DOMINION ENERGY NUCLEAR CONNECTICUT, INC.
MILLSTONE POWER STATION UNIT 2
RESPONSE TO REQUEST FOR ADDITIONAL INFORMATION FOR PROPOSED
LICENSE AMENDMENT REQUEST TO REVISE THE MILLSTONE UNIT 2
TECHNICAL SPECIFICATIONS FOR STEAM GENERATOR INSPECTION
FREQUENCY

**Response to Request for Additional Information for the
Proposed LAR to Revise TSs for Steam Generator Inspection Frequency**

**MILLSTONE POWER STATION UNIT 2
DOMINION ENERGY NUCLEAR CONNECTICUT, INC.**

Figure 1 – Orange Oxide on SG-2 Baseplate

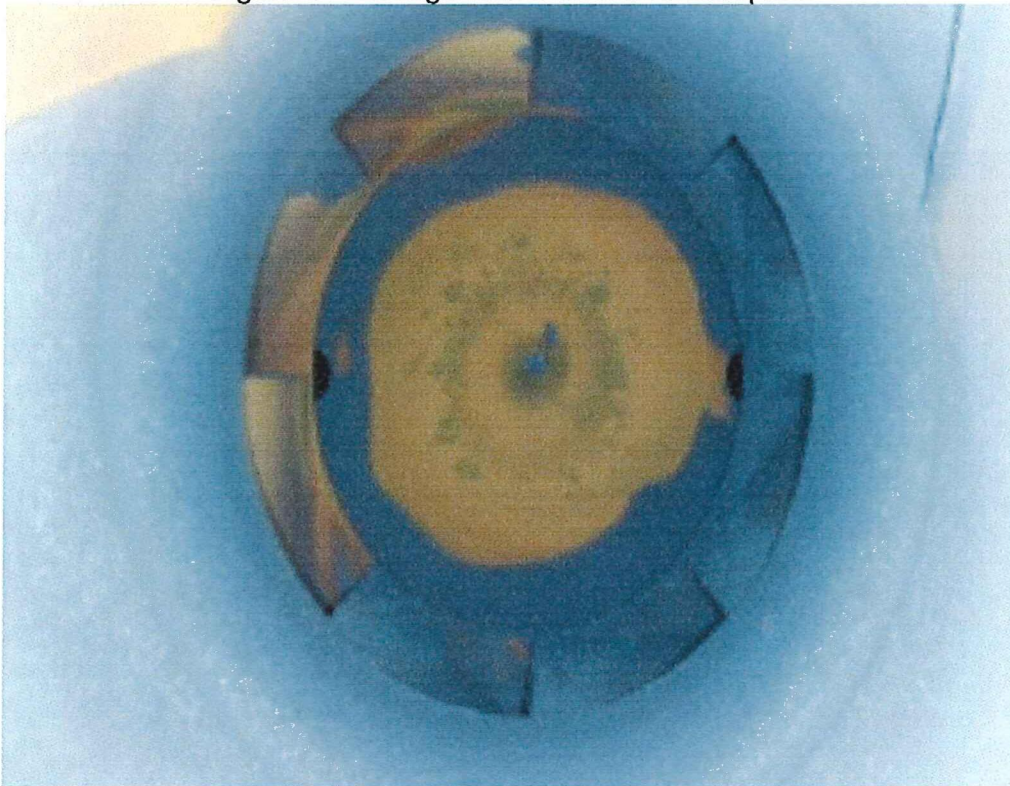
The Millstone Unit 2 spring 2017 SG tube inspection report (Reference 4) states, "Steam drum visual inspections to evaluate the material condition and cleanliness of key components such as moisture separators, drain systems, and interior surfaces," were performed in both SGs during refueling outage 24 (2R24). Reference 4 goes on to state, "The results of all secondary-side visual examinations performed were satisfactory, with no degradation detected." However, Section 4.3.1, "Steam Drum," of the Attachment to Reference 2 states, "Evidence of early stage flow assisted corrosion of the secondary moisture separators was noted." Figure 4-3, "Steam Drum Components," in the Attachment to Reference 2 includes a picture of early stage flow assisted corrosion in a separator baseplate. Section 4.3.1 goes on to state, in part, "...based on limited operational wear observed through 2R24, significant structural degradation is not expected to occur over the next five cycles of operation." The staff has the following requests regarding the flow assisted corrosion of the secondary moisture separators:

- a. Please discuss the discrepancy between Reference 2 and Reference 4 related to the results of the secondary-side visual examinations.*
- b. Please describe each location where flow assisted corrosion was observed in all SGs.*
- c. Please discuss how the flow assisted corrosion was evaluated to determine that "significant structural degradation is not expected to occur over the next five cycles of operation." In addition, please discuss how the condition will be monitored during future outages, for example, visual inspections, thickness measurements.*

up at the baseplate from below the secondary deck). Some regions of the separators exhibit a lack of magnetite, with no apparent loss of material thickness. This occurs most notably on the lower cylinder sidewalls and skimmer slots and occurs to a lesser extent on the baseplates and swirl vanes. These are the locations where the formation of orange oxides has been noted. These findings affect a small population of the secondary separators, mostly on the hot-leg side of the SGs. Figures 1 thru 4 below provide examples of these locations:

Video images were obtained of all secondary separators from above the secondary deck during EOC25. Of the 170 separators (per SG) inspected, approximately 25 showed a lack of tightly adhering magnetite (as evidenced by orange discoloration). Where discoloration was observed on the skimmer vanes, lower cylinder assembly sidewalls, swirl vanes, or baseplates, the visual inspectors scrutinized the discolored location for evidence of perforations or visible material loss. No perforations or visible material loss were evident, and the affected sidewalls and baseplates were smooth.
